Access Compliance Report

Public Rights-of-Way

(Curb Ramps)

Intersection ID: 11084	Main Street: E_25TH_ST	Cross Street: EVERETT_PL	Location: S
ADA ID: C54EF3ABB398	Ramp Type: Perp	Initial Pass/Fail: Fail	Overall Compliance: No
Severity Score: 21.25			
Codes/Mitigation Info/Possible Solution		Field Measurements/Component Compliance

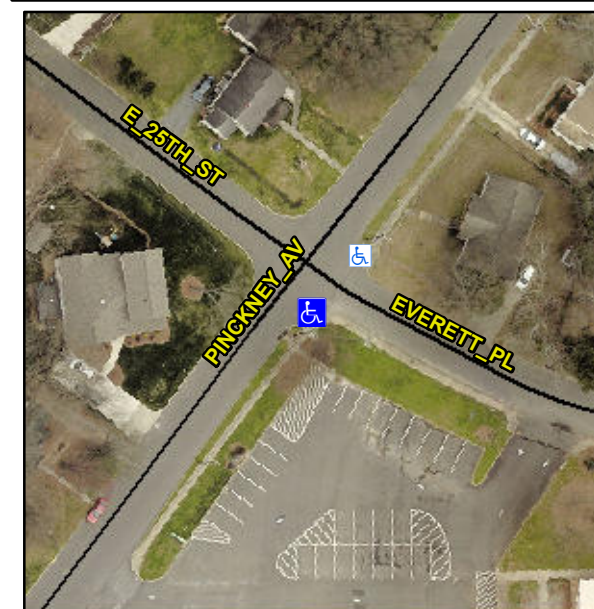
Not Found, R304.5.1, R304.2.2

Compliance	Description	Data	Compliance	Description	Data
N/A	Ramp Length (in)	62.0	No	Ramp Slope (%)	8.4
No	Ramp Width (in)	40.0	Yes	Ramp XSlope (%)	1.4
N/A	Flare Type LT	N/A	N/A	Flare Type RT	N/A
N/A	Flare Slope LT (%)	N/A	N/A	Flare Slope RT (%)	N/A
N/A	Flare Traversable LT?	N/A	N/A	Flare Traversable RT?	N/A
N/A	Landing Length (in)	N/A	N/A	DWS Provided?	N/A
N/A	Landing Width (in)	N/A	N/A	DWS Contrast?	N/A
N/A	Landing Slope (%)	N/A	N/A	DWS Length (in)	N/A
N/A	Landing X Slope (%)	N/A	N/A	DWS Full Width?	N/A
N/A	Landing Curb? (Y/N)	N/A	N/A	DWS Offset (in)	N/A
N/A	Shared Landing?	N/A			
N/A	Gutter Ponding?	N/A	N/A	Gutter Slope (%)	N/A
N/A	Gutter Lip Ht (in)	N/A	N/A	Gutter X Slope (%)	N/A
N/A	Painted X Walk1?	No	N/A	Painted X Walk2?	N/A
	X Walk 1 Direction	To NE		X Walk 2 Direction	N/A
N/A	X Walk 1 Width (in)	N/A	N/A	X Walk 2 Width (in)	N/A
	X Walk 1 Slope (%)	2.8		X Walk 2 Slope (%)	N/A
	X Walk 1 X Slope (%)	0.5		X Walk 2 X Slope (%)	N/A

Remove & Replace Entire Ramp.
